#### **Addendum 158 – UN Regulation No. 159**

##### **Amendment 1**

Supplement 1 to the original version of the Regulation – Date of entry into force:  
22 June 2022.

#### **Uniform provisions concerning the approval of motor vehicles with regard to the Moving Off Information System for the Detection of Pedestrians and Cyclists**

**Figure 1**  
Set Up for Static Crossing Tests

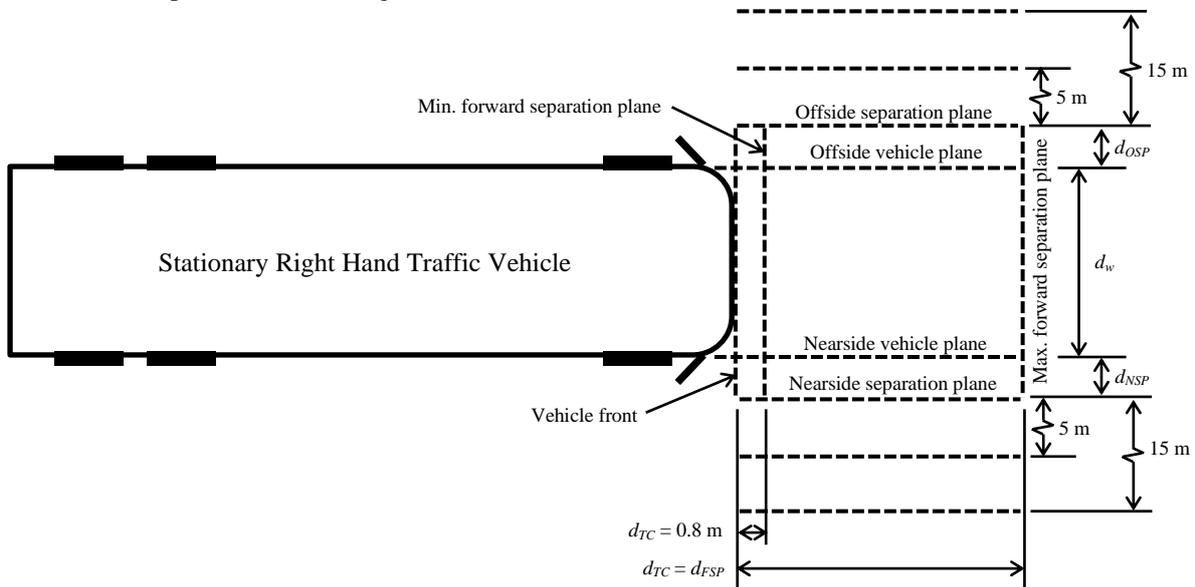
Appendix 1, amend to read:

Where the following definitions apply:

- $d_w$  vehicle width.
- $d_{NSP}$  the distance from the nearside vehicle plane to the nearside separation plane, defined as 0.5 m.
- $d_{OSP}$  the distance from the offside vehicle plane to the offside separation plane, defined as 0.5 m.
- $d_{TC}$  the forward separation distance for each test case.
- $d_{FSP}$  the distance from the vehicle front to the maximum forward separation plane.
